COUNCIL ASSESSMENT REPORT

Panel Reference	2018SWC052
DA Number	1867/2018/JP
LGA	The Hills Shire Council
Proposed Development	Demolition of existing structure and construction of a Place of Public Worship and associated parking and landscaping.
Street Address	1 Larapinta Place Glenhaven
Applicant/Owner	Iconfm Australia Pty Ltd / Hills AWQAF Pty Ltd
Date of DA lodgement	19 April 2018
Number of Submissions	1068 (including 40 in support)
Recommendation	Refusal
Regional Development Criteria (Schedule 7 of the SEPP (State and Regional Development) 2011	Private infrastructure and Community Facilities exceeding \$5 million
List of all relevant s4.15(1)(a) matters	<ul style="list-style-type: none"> • Section 4.15 (EP and A Act, 1979) • SEPP State and Regional Development 2011 • SEPP 55 Remediation of Land • SEPP BASIX 2004 • SREP 20 – Hawkesbury Nepean River • LEP 2012 • DCP Part B Section 1 - Rural • DCP Part C Section 1 – Parking • DCP Part C Section 3 - Landscaping

EXECUTIVE SUMMARY

ATTACHMENT 3 – SITE PLAN

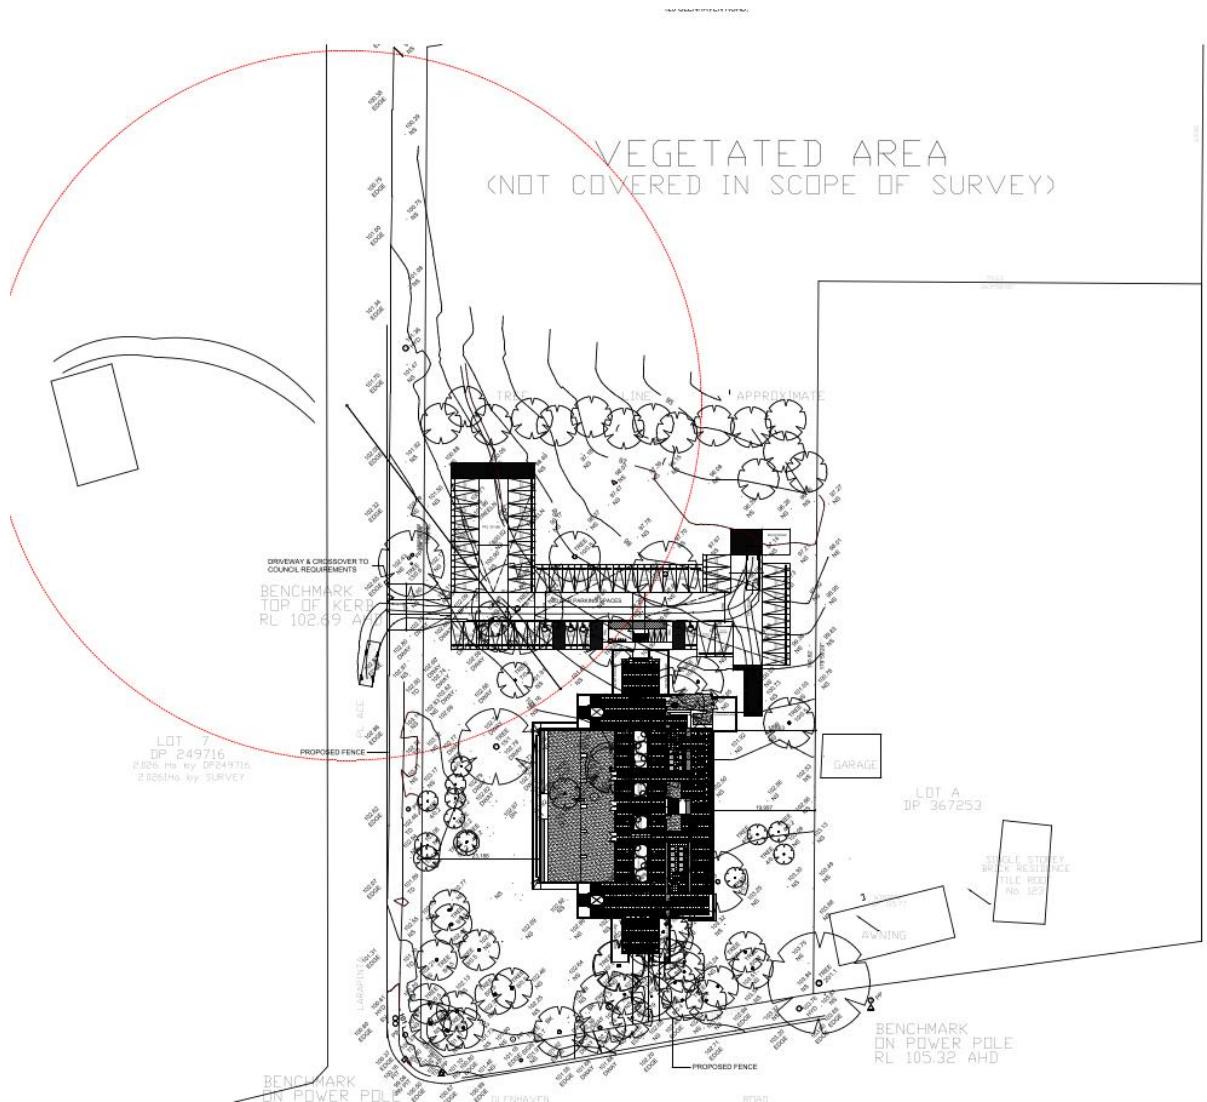
The arborist assessment has identified trees which are required to be retained and trees suitable for removal. The site plan (Drawing No. 1001) is an overlay of the survey plan and identifies all trees on the northern part of the site, suggesting that all trees are to be retained. The landscape plan however does not include trees which are identified in the arborist report as trees to be retained. This plan indicates that many of the trees identified as to be retained are also proposed to be removed.

ATTACHMENT 9 – STREETSCAPE ELEVATION AND FENCE DETAIL

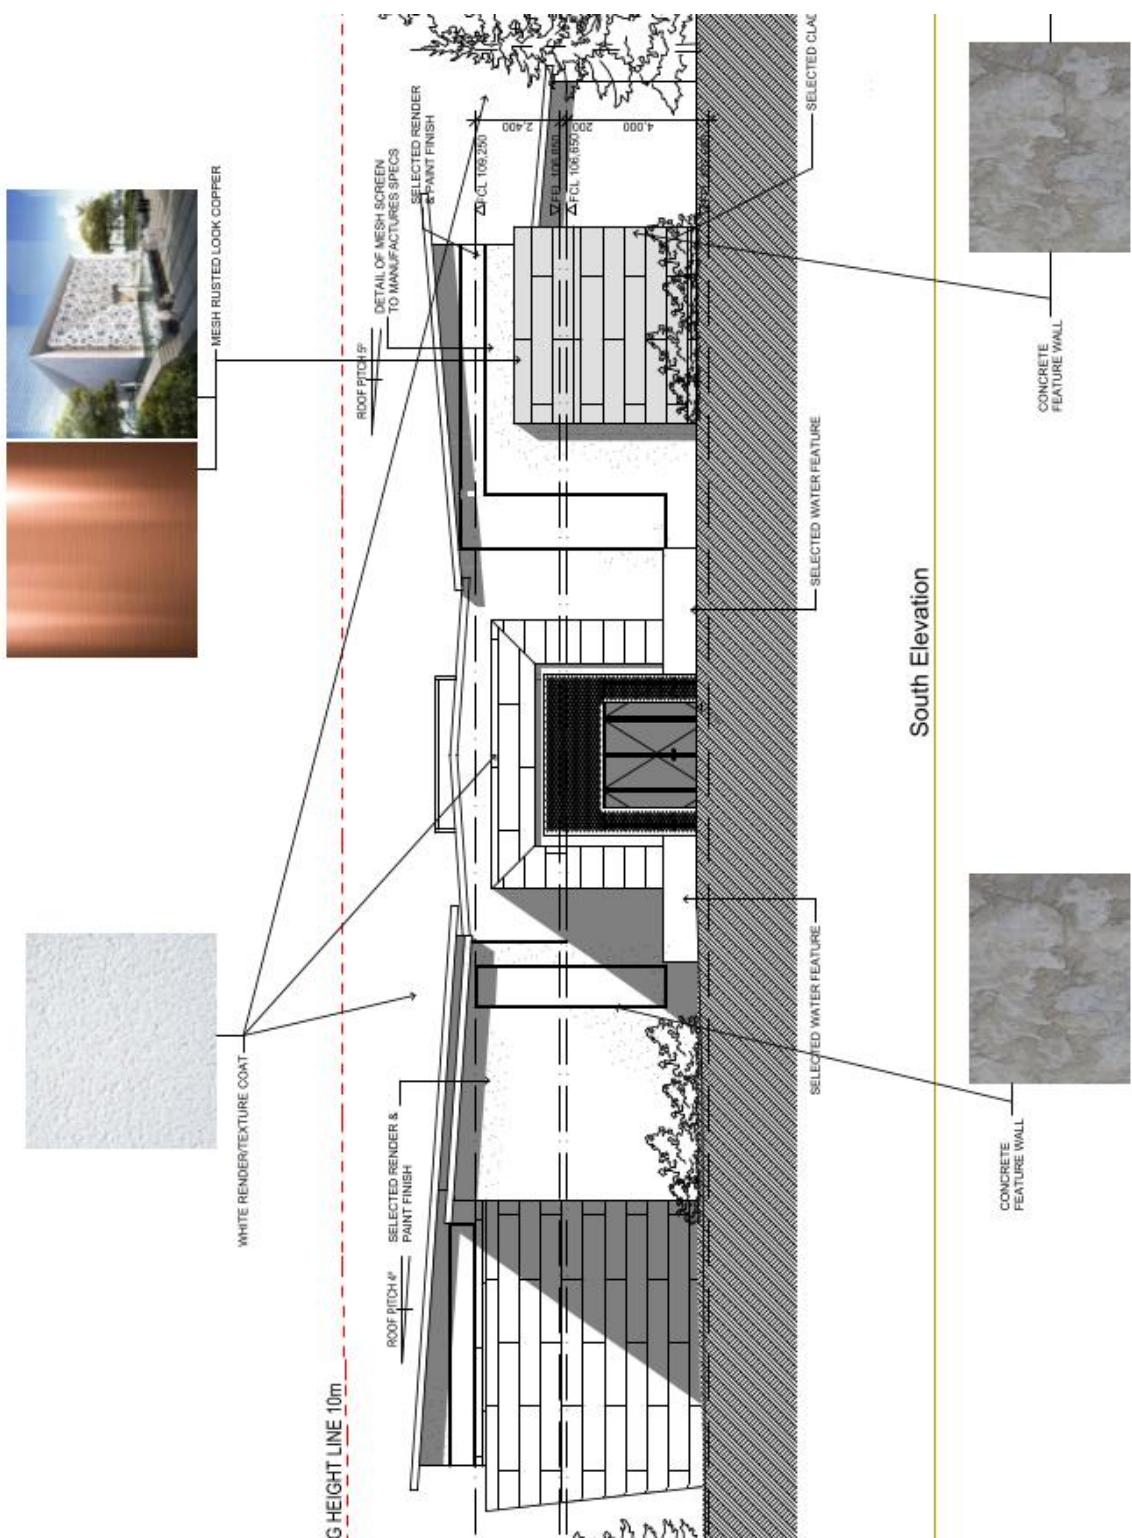
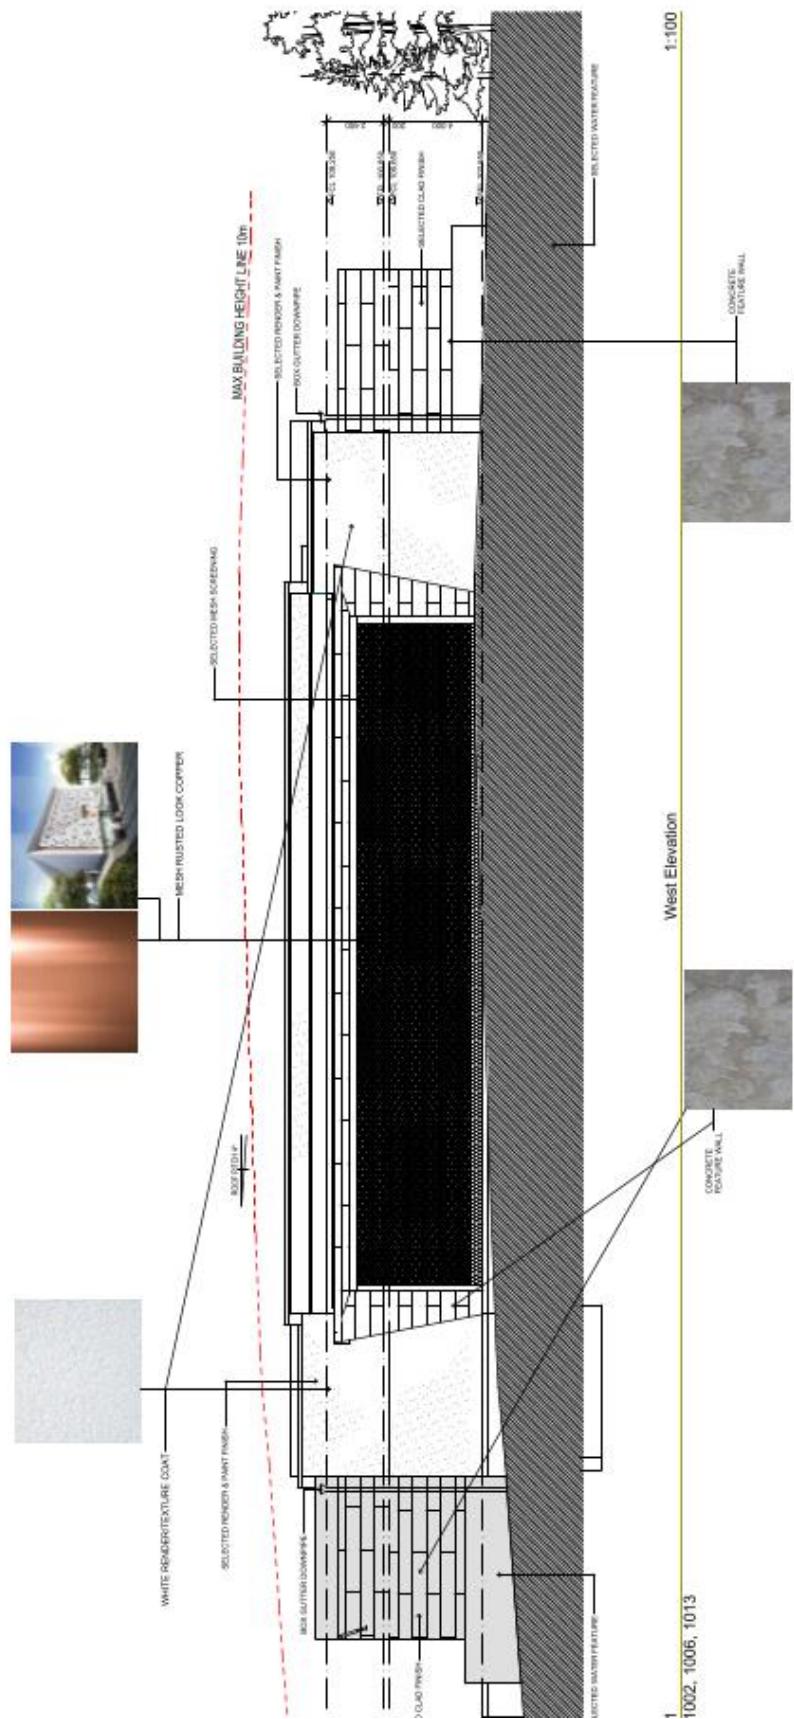
Front fence must be of open style and not solid masonry or solid panel construction. The design is to be in accordance with DCP requirements and be of an open style rather than solid panels, further fencing detail are required.

ATTACHMENT 11 – LANDSCAPE PLAN

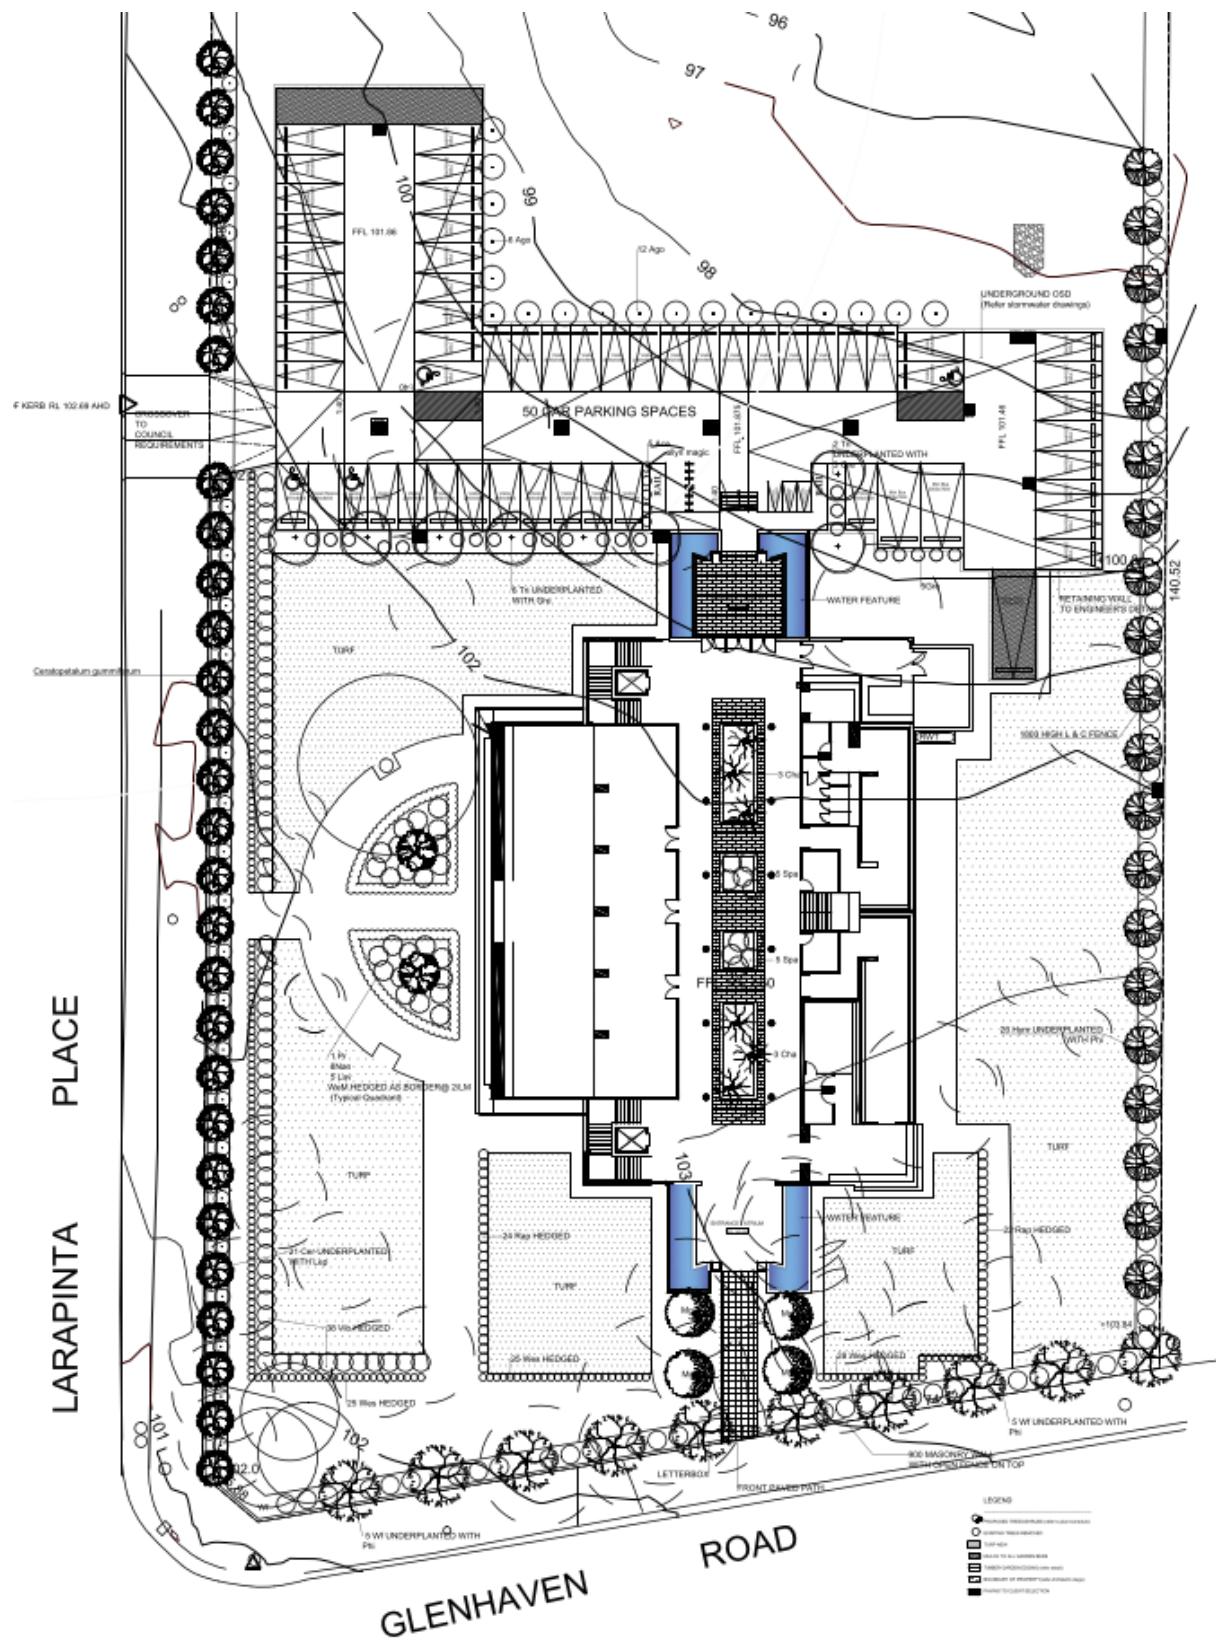
The proposal provides only 2 metres of landscaping along the eastern side boundary and along the Larapinta Place frontage. The applicant has not provided a planting schedule (as requested) nominated the species with the landscape plan, therefore the species, the size, densities, etc. is unknown.

Furthermore, the landscape plan does not include any details of the species of trees or plants proposed to be provided or whether the proposed landscaping has had regard to the RFS General Terms of Approval which require the maintenance of the areas around the building to the east, south and west as an inner protection area (IPA). The requirement to maintain these areas as IPAs might result in less planting than the planting proposed on the landscape plan in which case the potential screening that the proposed landscaping might have provided will not eventuate.

The development is to provide proposed levels to landscape plan to paths and turfed areas especially at the junction with carparking areas and to boundaries.

No plant schedule has been provided indicating species name, size and quantities.

The development is to provide minimum 3m wide dense landscape screening to side and rear boundaries as required by the DCP. This landscape strip is to include native species from Sandstone Heath and Sandstone Gully Forest species within planting palette for trees, shrubs and groundcovers.

It is also noted that the landscape plan and architectural plans are inconsistent in relation to the car parking layout.
